UNITED STATES PATENT AND TRADEMARK OFFICE

10/597,910

Office Action Summary

HESELDEN, JAMES

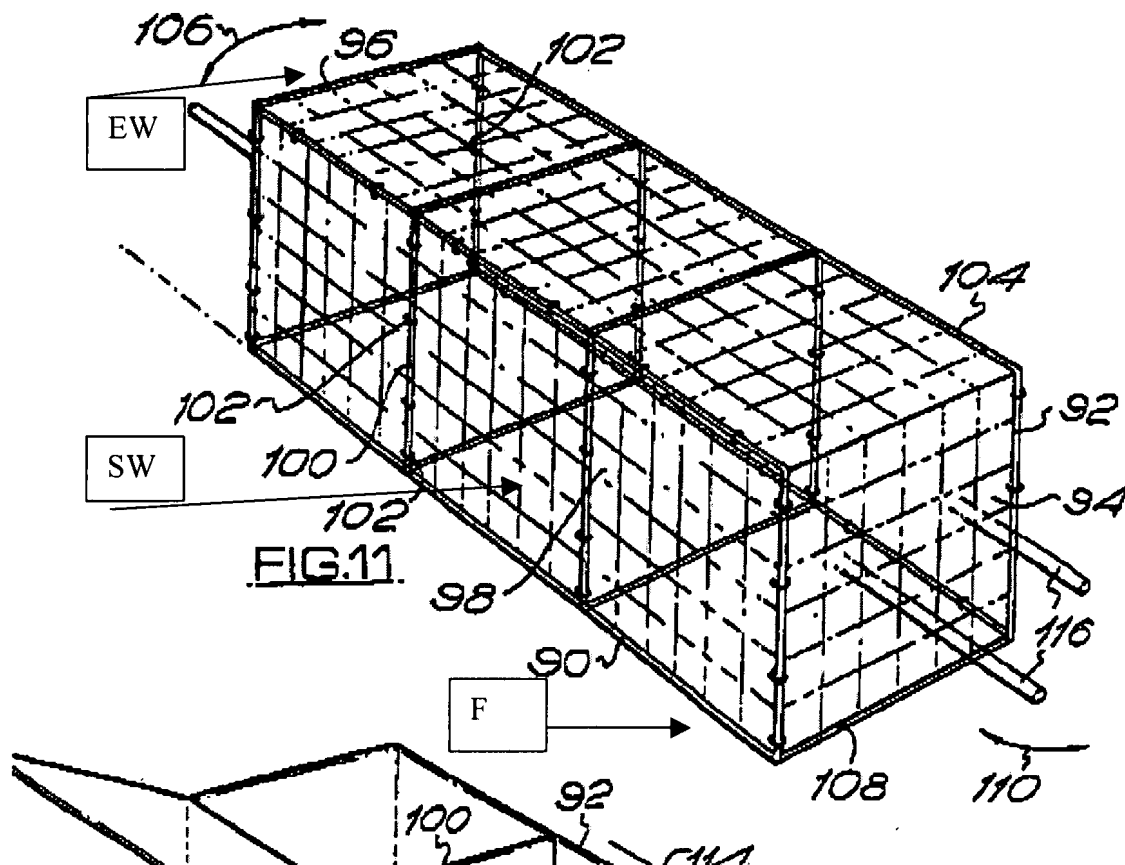
Heselden —e.g. figure 11—reproduced below--describes the cage structure comprising opposed side walls (marked "SW" by examiner) connected by opposed end walls ("EW") , the structure having on at least one side or end wall a façade ("F") spaced from the wall to accommodate a surface effect material as claimed in claim 1. Note, Heselden shows what might be conventionally considered as three connected gabions, however, the endmost structure (F) meets the structural limitations of the façade.

RE claims 6 and 7: Heselden plainly shows the pivotal connections at or near 102.

Heselden describes the cage structure (see, e.g. figure 11) the structure having on at least one side or end wall and an insert spaced from the wall to accommodate a surface effect material as claimed.
